# UNITED STATES PATENT AND TRADEMARK OFFICE

APPLICATION NO.	FILING DATE	FIRST NAMED INVENTOR	ATTORNEY DOCKET NO.	CONFIRMATION NO.
09/418,902	10/15/1999	WALTER V. KLEMP	P01896US0	9464
23770	7590	01/21/2004		
PAULA D. MORRIS & ASSOCIATES, P.C. 10260 WESTHEIMER, SUITE 360 HOUSTON, TX 77042				
			EXAMINER KIDWELL, MICHELE M	
			ART UNIT 3761	PAPER NUMBER

# Office Action Summary

## **DETAILED ACTION**

**FIG. 5**

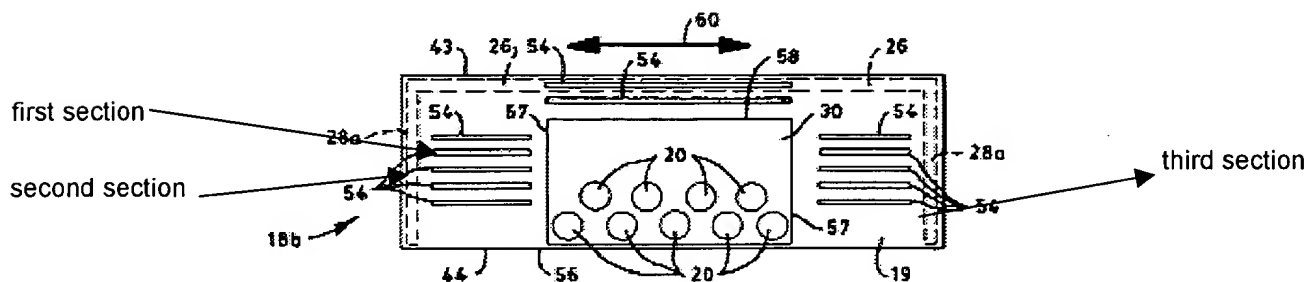
With respect to claim 1, Turner et al (hereinafter referred to as Turner), teaches a disposable absorbent article having side and end edges (10), a topsheet layer (12), a backsheet layer (14), an absorbent core (16), and an end strip (18, 19) as shown below:

Turner discloses the first section having generally elastic properties (col. 9, lines 54 – 67) and laterally extending in generally parallel relation with the end edges (figure 1), and the second section can be understood to be substantially less elastic than the first section since the second section does not include the elastic strand. Likewise, the second section extends in generally parallel relation therewith (figure 5). Additionally, Turner teaches the third section (the next elastic section) being spaced away from the topsheet and core as set forth in col. 4, lines 65 – 66. Further, Turner discloses each section of the end strip to be distinctly elastic (col. 9, lines 54 – 67) and distinctly positioned relative to said other sections (i.e., the section with the elastic strand is different from section without the elastic strand).

With reference to claims 68 – 69 and 71, see figure 5.
